Re: Unorthodox Location
Consolidated Oil & Gas, Inc.
Nance 1-E

SUNDRY NOTICES AND REPORTS ON WELLS

Re: Application for Non-Standard
Location: Nance 1-E, 590'
FSL and 1850' FWL of Sec. 27,
T-31-N, R-13-W, San Juan County,
New Mexico

RE: Relocation of Well Pad Nance #1E

NEW MEXICO OIL CONSERVATION COMMISSION
 PLAT LOCATION AND ACREAGE DEDICATION

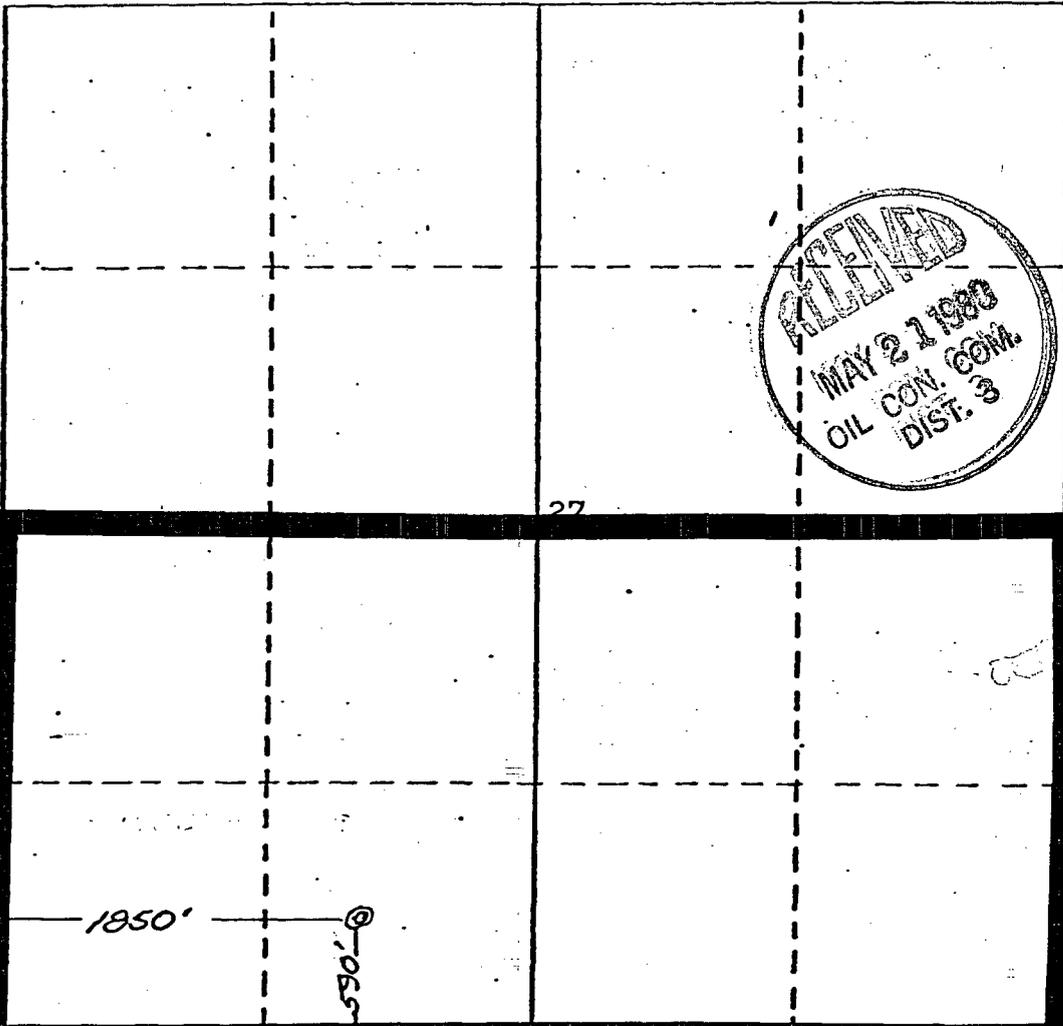
Operator CONSOLIDATED OIL & GAS, INC.		Lease NANCE		Well No. 1-E
Unit Letter N	Section 27	Township 31 NORTH	Range 13 WEST	County SAN JUAN
Actual Footage Location of Well: 590 feet from the SOUTH line and 1850 feet from the WEST line				
Ground Level Elev. 5595	Producing Formation DAKOTA	Pool BASIN	Dedicated Acreage: 320 Acres

Figure 1

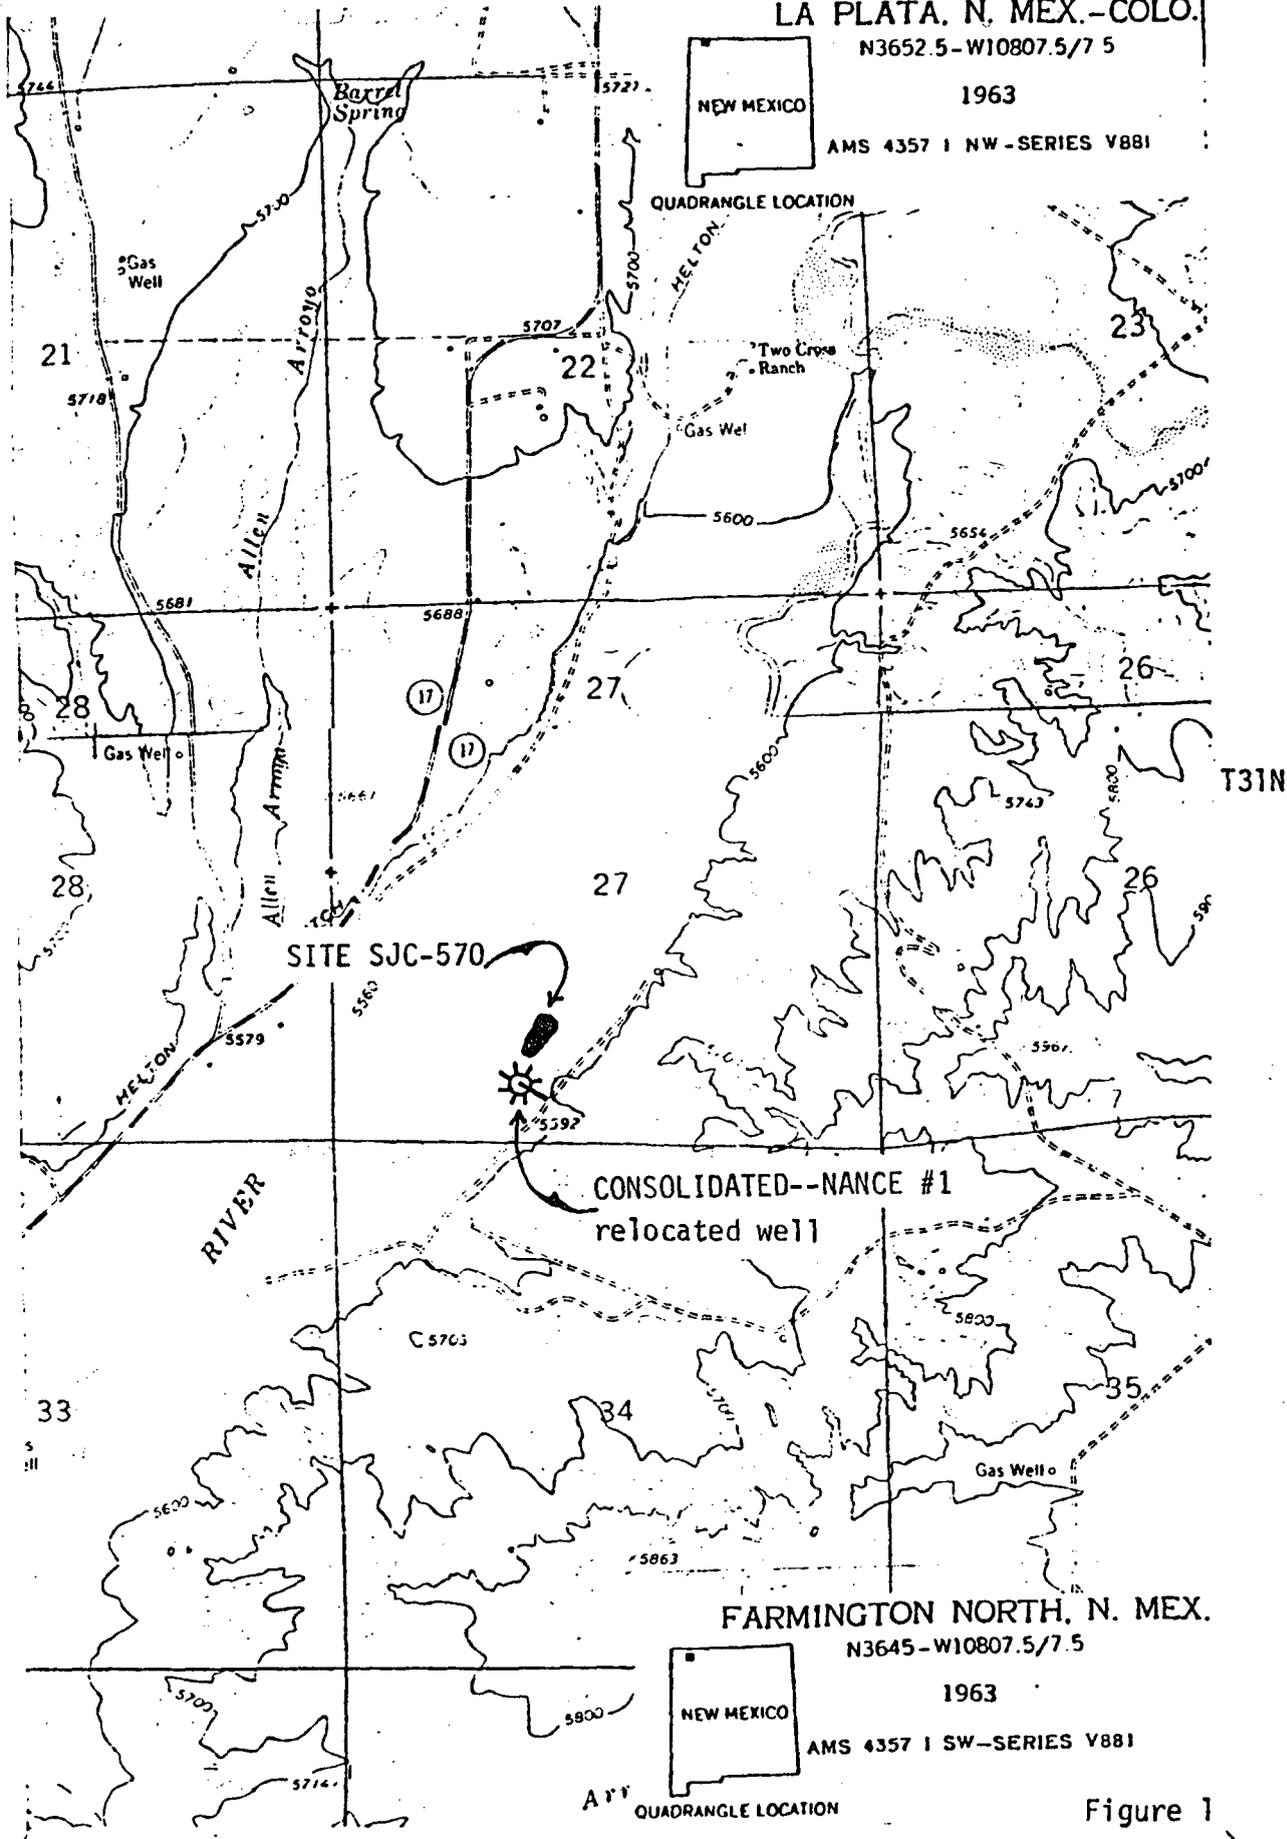
Location: The proposed location is in the SW $\frac{1}{4}$ of the SE $\frac{1}{4}$ of the SW $\frac{1}{4}$ of Section 27, Township 31 North, Range 13 West, N.M.P.M., San Juan County, New Mexico. The well will be 590 feet from the south line and 1850 feet from the west line of Section 27. (Figure 1)

Cultural Resources: Site SJC-570 was found on the original well location. The stake was moved 200 feet south to completely avoid the site.

Recommendations: With the relocation of the well, archaeological clearance is recommended.
